Metropolitan Development Commission Regional Center Hearing Examiner (November 14, 2024) Meeting Agenda

Case Number	2024-REG-055
Address (approx.)	2163 and 2179 North Illinois Street
Location	Center Township, Council District #12
Petitioner	Near North Development Corporation, by Audra Blasdel
Zoning	MU-2 (RC); D-8 (RC) (pending)
Request	Regional Center Approval to provide for a 20-unit townhome development, consisting of six buildings.

REGIONAL CENTER HEARING EXAMINER - HIGH IMPACT CASE

Landscape plan

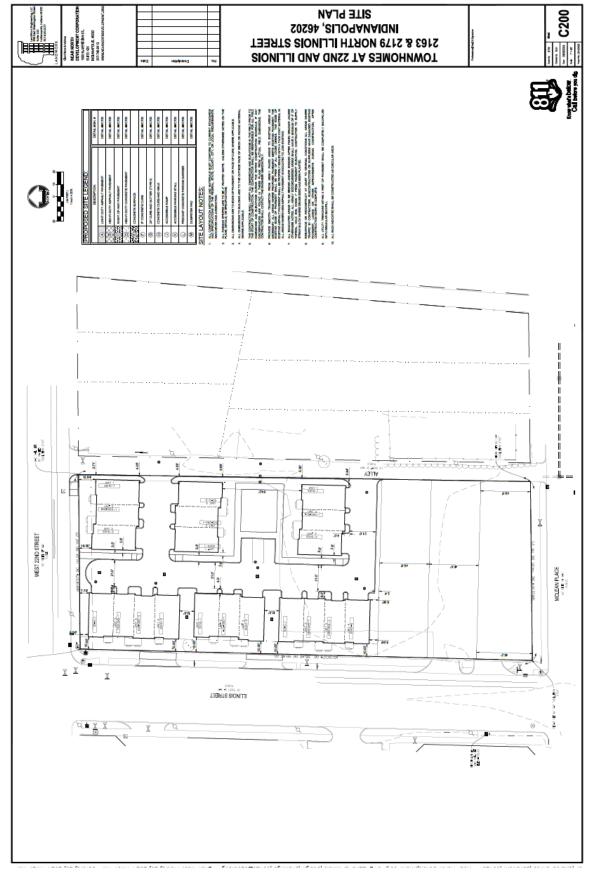
- 3. A preliminary landscape plan was submitted; however, plant species plans were not submitted. Staff would specifically request additional trees to be added to open areas within proposed grass areas. Therefore, a detailed landscape plan, with plant species types, must be submitted prior to the issuance of an Improvement Location Permit. Guidelines US 1.3.2, CA 4.6.1, CA 4.6.4, and CA 4.6.5 would apply.

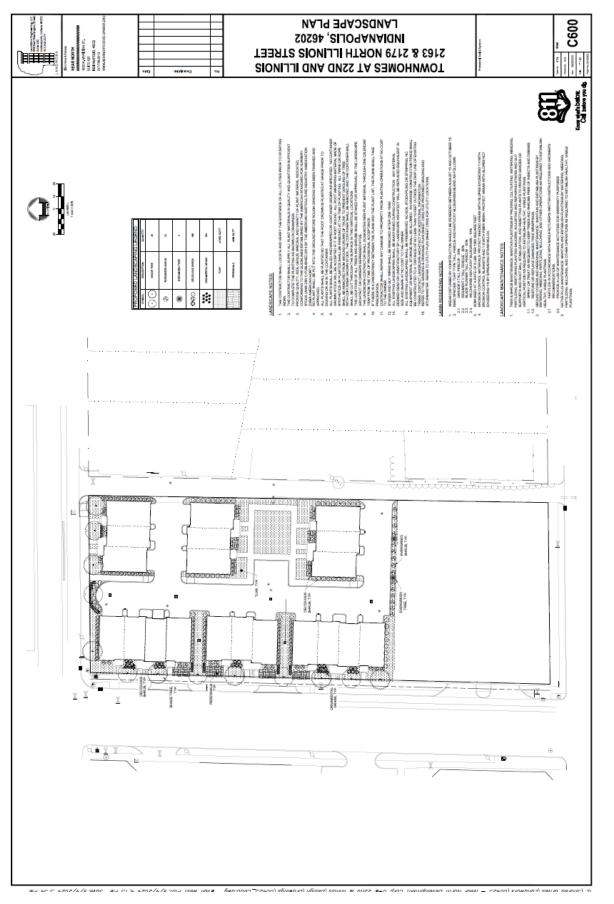
- 2. The building materials would be primarily manufactured fiber cement, which is a common building material use. However, the Guidelines require natural buildings materials, such as masonry, limestone, granite, concrete and metal panels. Guideline CA 2.2.1 would apply. The Guidelines do permit wood siding (CA 2.2.3), which fiber cement is intended to be an alternative to wood siding due to less maintenance costs over the lifetime of the structure. However, the use of wood is more environmentally friendly. In this case, the use of fiber cement is acceptable as the location is not abutting the City's main street, Meridian Street. Therefore, the use of fiber cement would be an acceptable deviation of the Guidelines, in this instance.
